Technical Bulletin

Bulletin No.: TCH-013-002

Subject: M-21 and M-22 Modulator Interchange

Figure 1 M-21 and M-22 Antilock Modulators

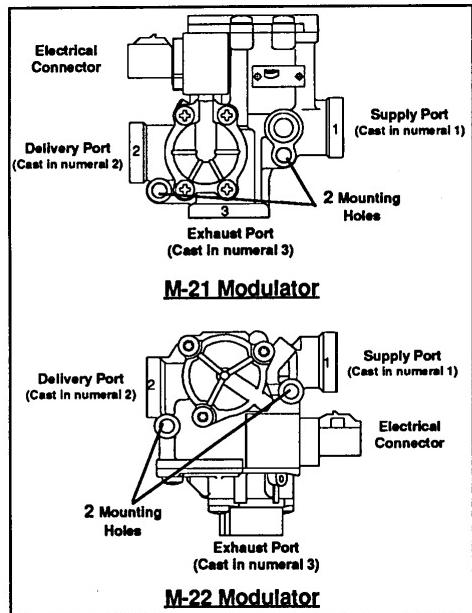
1. Study figures 1 & 2 and note where the exhaust port is located on both the M-21 and M-22. The exhaust on both modulators must be directed toward the road surface when mounted on the vehicle.

2. Note that the delivery port (to the brake chamber) for the M-21 is on the same side as the electrical connector. The M-22 is exactly reverse of this with the delivery port on the side opposite the electrical connector.

Note: The position of the Supply Port, Delivery Port, and Exhaust Port determine how the modulator must be mounted NOT THE ELECTRICAL CONNECTOR.

Figure 2 M-21 and M-22 Antilock Modulator Interchange

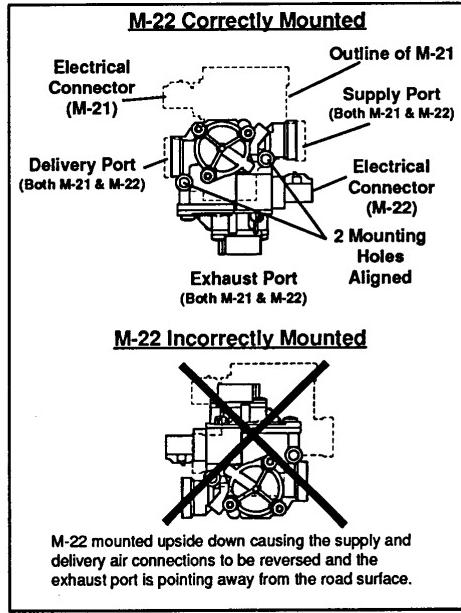
3. In all cases the electrical wire harness must be rerouted, reconnected to the M-22 and securely fastened.

IMPORTANT: The wire harness must not be STRAINED. A two inch radius must be maintained in the wire harness to assure it will not pull out of the connector or allow water to enter the connector. Early issues can be expected if the wire harness does not have adequate strain relief.
